RE: Grantline 220 Large Lot & Small Lot TSM (DD9837)

WALKSacramento has reviewed the project routing for Grantline 220 Large Lot & Small Lot TSM (DD9837) and we offer the following comments.

Figure 2 Neighborhood Street Connections in the Grantline 220 LL & SL TSM

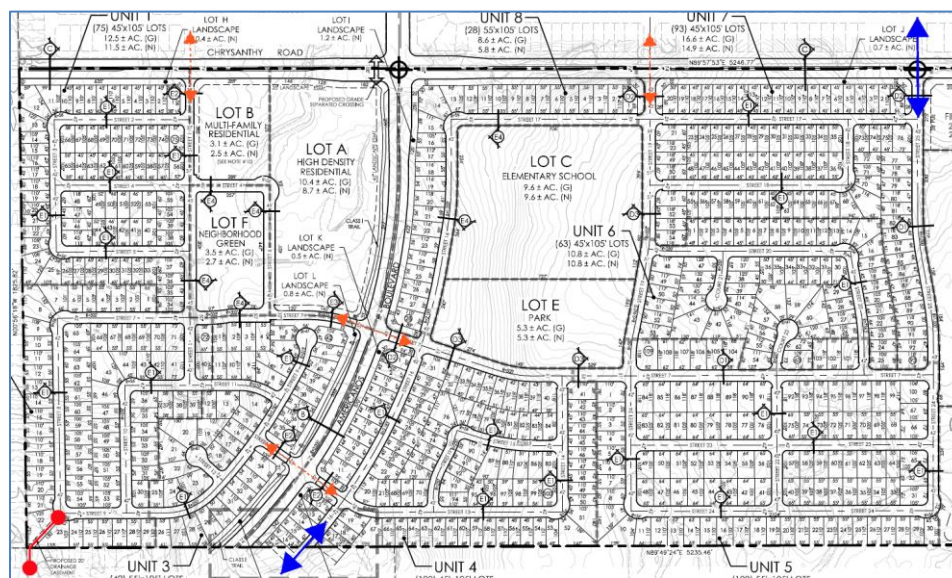
The Grantline 220 project, as proposed in both the initial and revised submittals, provides neighborhood street connections to surrounding development at only two places (solid blue arrows in Figure 2, below). Street 25 connects to Arista Del Sol to the north, and Street 16 connects to Sierra Sunrise to the south. There are two other neighborhood streets between Grantline 220 and Arista Del Sol that intersect with Chrysanthy Road, and two between Grantline West and Grantline East that intersect with Americanos Boulevard. Since we believe pedestrian and bicycle crossings of the minor arterials will likely require pedestrian or traffic signals and none are proposed, we haven't included those four streets (dashed orange in Figure 2) as making complete connections between neighborhoods.

There is also a 20' drainage easement at the southwest corner of Grantline 220 that connects to a 20' drainage easement in Sierra Sunrise. While the easements might afford the opportunity for a pedestrian or pedestrian/bicycle connection between neighborhoods, the bend in the pathway hampers adequate natural surveillance so we don't consider the potential connection (solid red in Figure 2) to be complete, even for active transportation.

Figure 6 Large Blocks and Missing Connections

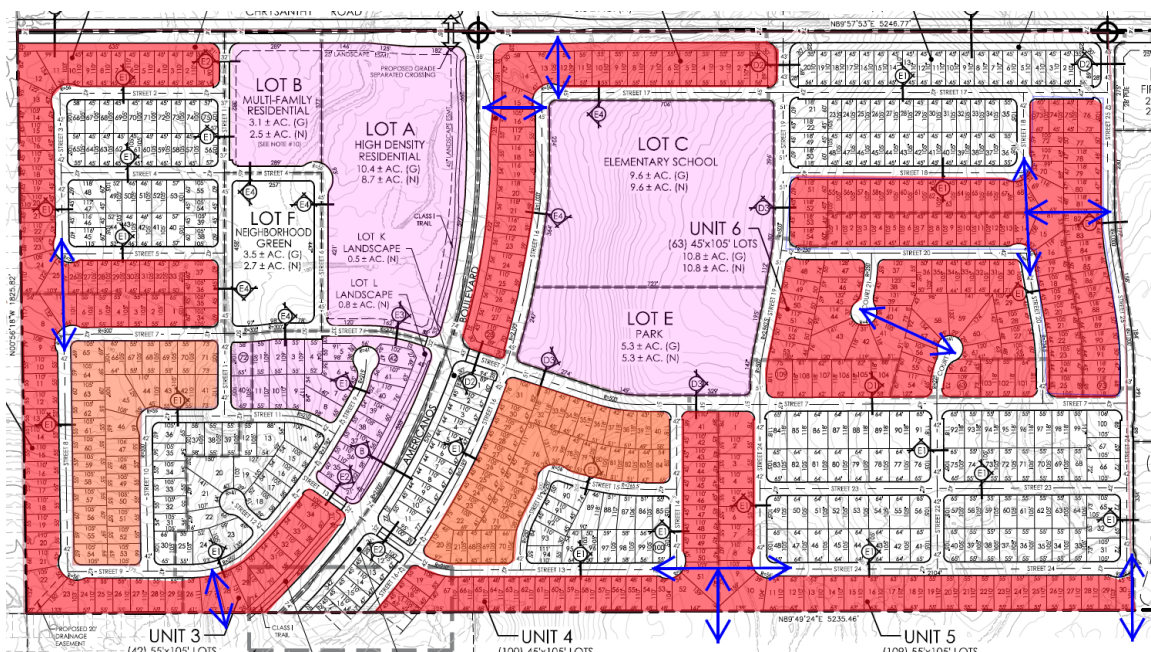
There are several large blocks in the Grantline 220 project that will diminish the connectivity. Figure 6 shows the large blocks shaded red. The orange shading indicates blocks that are marginally large and whose shapes require out-of-direction travel; the lavender shading indicates large blocks that should be permeable to pedestrians and bicyclists via walkways in the park and the cul-de-sac and via easements with walkways between the multifamily parcels and through the larger multifamily parcel. Blue arrows indicate missing connections.
